# Final Precursor Analysis

Accident Sequence Precursor Program --- Office of Nuclear Regulatory Research

Nine Mile Point 2	Automatic Reactor Trip and Loss of Offsite Power Due to the August 14, 2003, Transmission Grid Blackout	
Event Date 8/14/2003	LER: 410/03-002	CCDP <sup>1</sup> = $2 \times 10^{-5}$

December 17, 2004

**Figure 2: Nine Mile Point 2 SBO event tree with dominant sequence highlighted.**

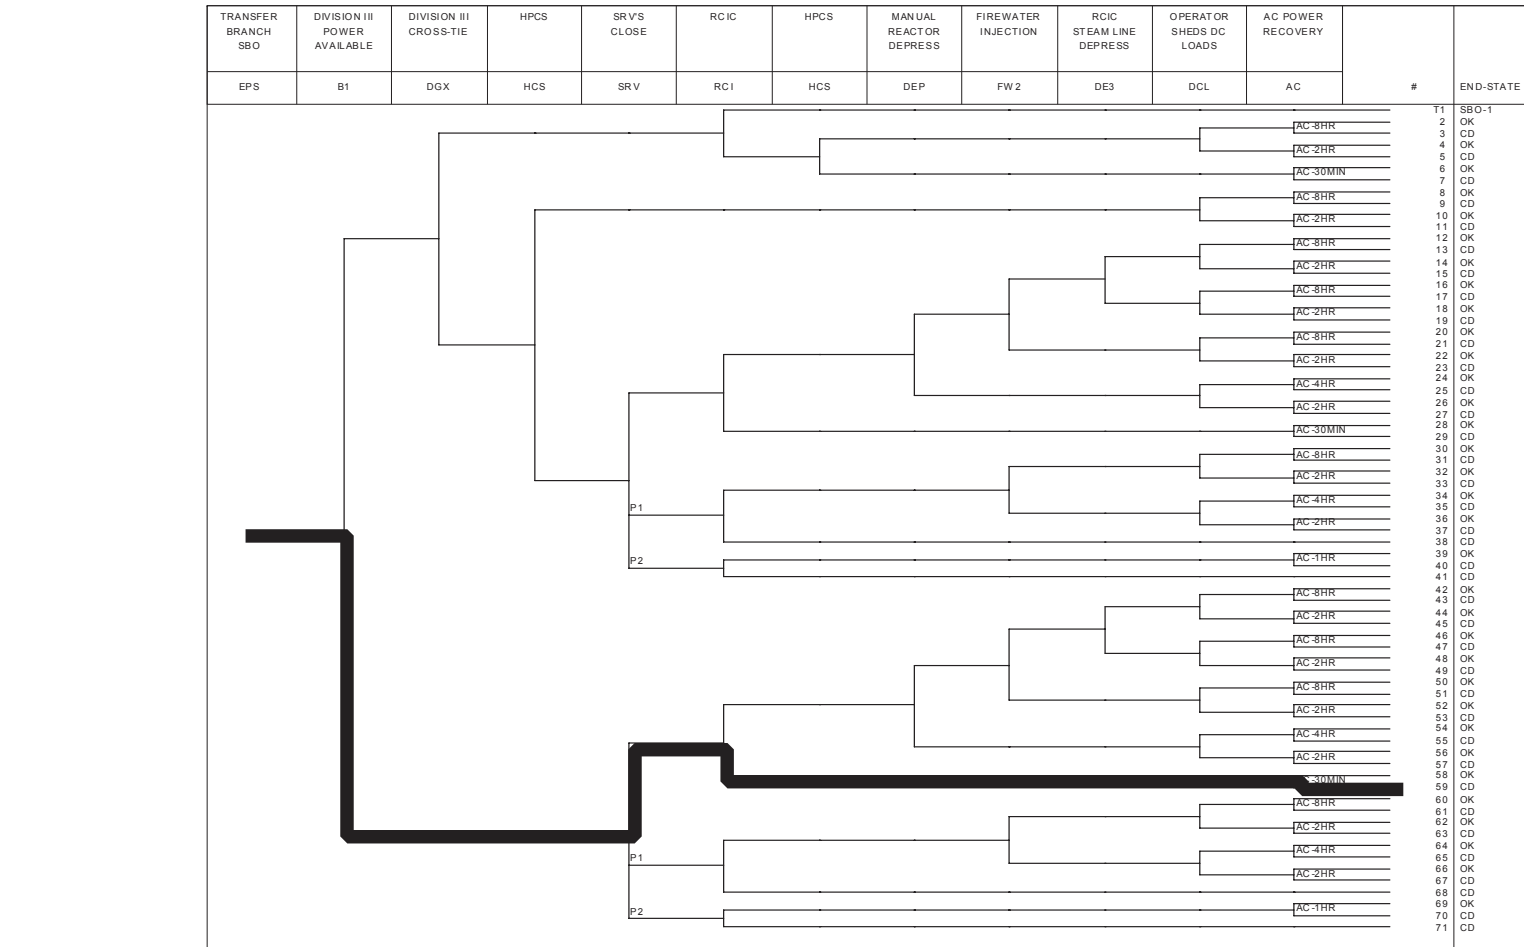
**Sequence 46-49:** "The PPA summarizes a set of dominant accident cutsets wherein a LOSP initiator occurs followed by Div 1 EDG failure, Div 2 EDG failure, Div 3 EDG Failure, and failure of RCIC to start. For this event, condensate-feedwater would have been available and redundant to RCIC. Condensate-feedwater is supplied by the non-safety AC system which remained available from offsite power. With loss of 115 kV to the emergency switchgear and no EDGs operating, service water pumps would be idle. This would eliminate the heat sink for Turbine Building Closed Loop Cooling (TBCLC), which is required for pump cooling. Therefore, condensate-feedwater could not be credited with RPV level control over the long term but it would support success throughout the first phases of Station Blackout (SBO) response. It is recommended that the PPA analysis model this case using an "AND" gate for feedwater and early RCIC operation such that these sequences would be recoverable up to 2 to 4 hours. When combined with fire pump or Control Rod Drive (CRD) operation, see below, AC recovery for up to 8 hours may also be justifiable in the PPA model. Note that CRD has a similar support requirement to feedwater in that reactor building closed loop cooling (RBCLC) is required for long term component cooling."

**Response:** We agree with the licensee that some credit should be given for condensate and feed in Sequence 46-49 (Sequence 46-59 in new model). However, the change was not made due to model and time constraints. In addition, the change would not have affected the overall CCDP greatly.
